MEMORANDUM

SUBJECT: San Antonio Water Company Headquarters Project Initial Study/Mitigated Negative Declaration - Response to Comments

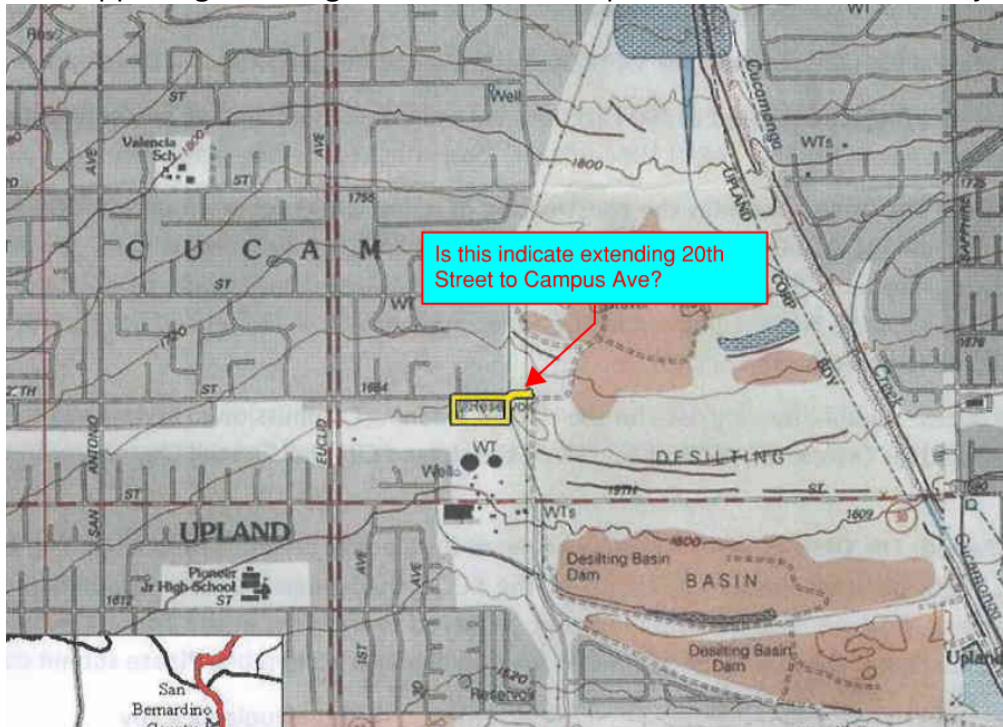
I received a notice in the mail about the above property at 400 East 20th Street. As part of this proposed development the map seems to show 20th Street extending to the east and connecting with Campus Ave. Is this the case? I think there will be significant objections to this happening. Please give me a written response to this email. Thank you.

Response G-1 This comment requests clarification regarding whether the Project proposes to connect East 20th Street and Campus Avenue. The Project does *not* include a connection between East 20th Street and Campus Avenue. Public access will occur only via East 20th Street, while all employee, delivery, and operational traffic will use the new driveway on Campus Avenue. This design prevents cut-through traffic on residential streets and ensures safe and efficient circulation for both public and operational uses.
